CALCULATIONS (New VAULT):
Proposed Horse Boarding Barn
Toilet and Sink (Infrequent Use, Non-Occupied Structure)

Project: 26-0279	Project Address
Sheet: 1 of 3	Tiffany & Jonathan Perez
Date: 2 June 2026	2850 Mount Herman Road
Revised:	Tract 10, Panoramic Acres,
Drawn by: DJP	Sch. No. 7122001003
Checked by: DJP	El Paso County, Colorado

V1_Site Plan Drawing_Copy_With Markup Summary.pdf Markup Summary

VICINITY PLAN

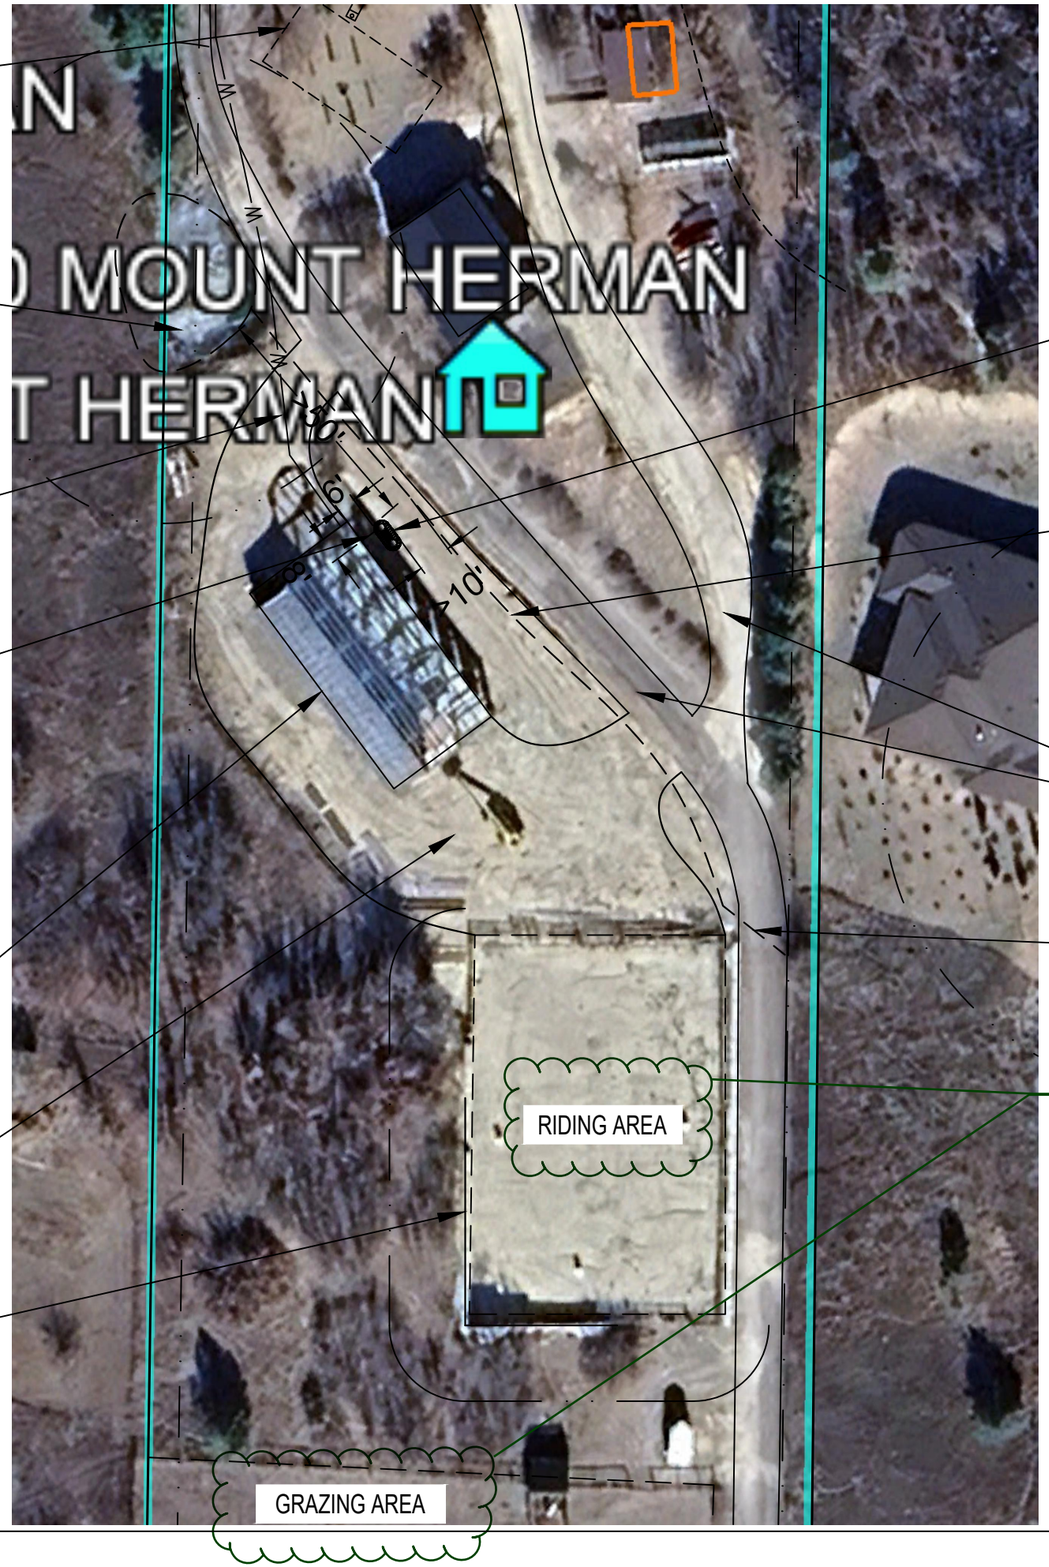
1. Label setback distances from proposed barn structure to all property lines.
2. Include barn structure square footage.
3. Provide location, square footage, dimensions and setback measurements from structures to property lines of all structures on the property and provide principal home square footage footprint.
4. Provide distance measurements from all intended corral areas to all property lines. Must be 25ft from property lines and 35 ft from any residential building on adjoining lots
5. Provide orientation of open-sided barn, if any. Open-end must face interior unless 100ft from property lines.
6. Highlight ALL corral areas on site plan.
7. See Site Plan checklist and show all requirements on site plan.
8. Show parking area.

Please label square footage of the barn structure.

Verify limits of disturbance for the stable area. Land disturbances greater than 1 ac require an Erosion and Stormwater Quality Control Permit, ESQCP, and Permanent Control Measure, PCM pursuant to Appendix I of the EPC Engineering Criteria Manual. Specify the limits in the LOI and Site Plan so the extent of the development is clear.

Clarify riding, grazing, and corral areas. Make consistent on page 1 and 2 of site plan.

If any other development/disturbance will be included as a part of this special use application, please depict on the site plan.

Please add label: Public Minor Collector

DETAILED SITE PLAN

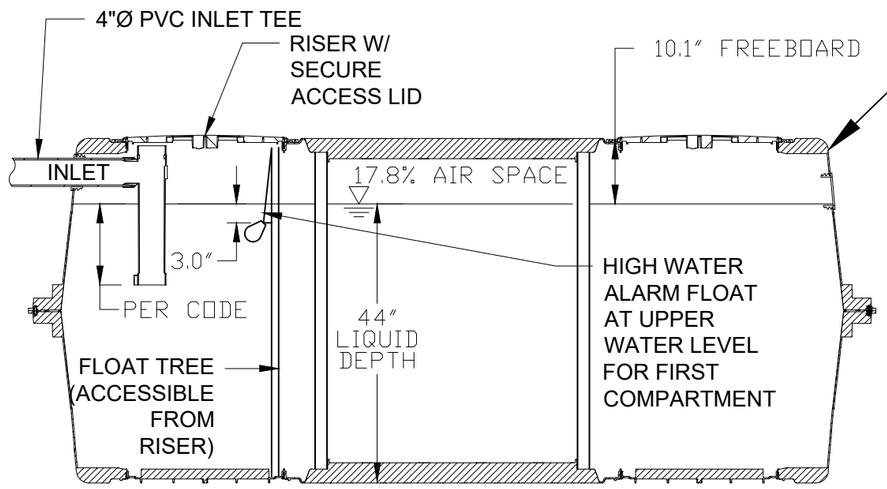
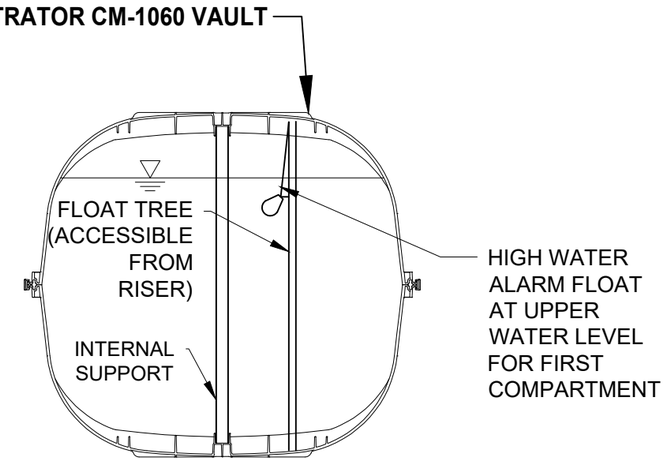
Clarify riding, grazing, and corral areas. Make consistent on page 1 and 2 of site plan.
